423 Euclid Street Woodland Heights

#### **CERTIFICATE OF APPROPRIATENESS**

**Proposal:** Alteration – Addition

November 14, 2017 HPO File No. 171115 423 Euclid Street
Woodland Heights

# **3D RENDERING – FRONT FACING EUCLID**PROPOSED

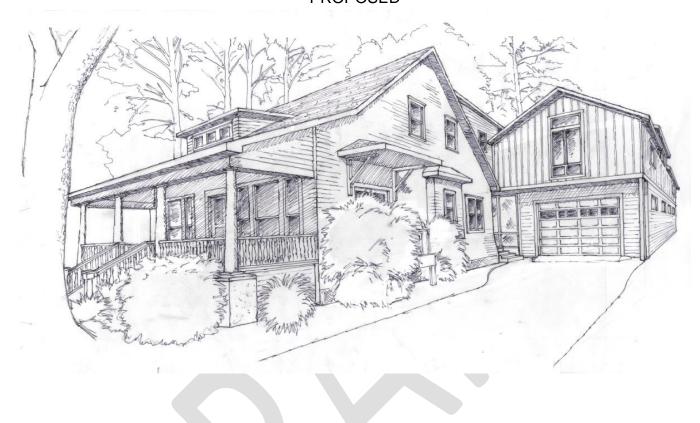
• A front dormer will be reconstructed based off a tax photo. See p. 5.
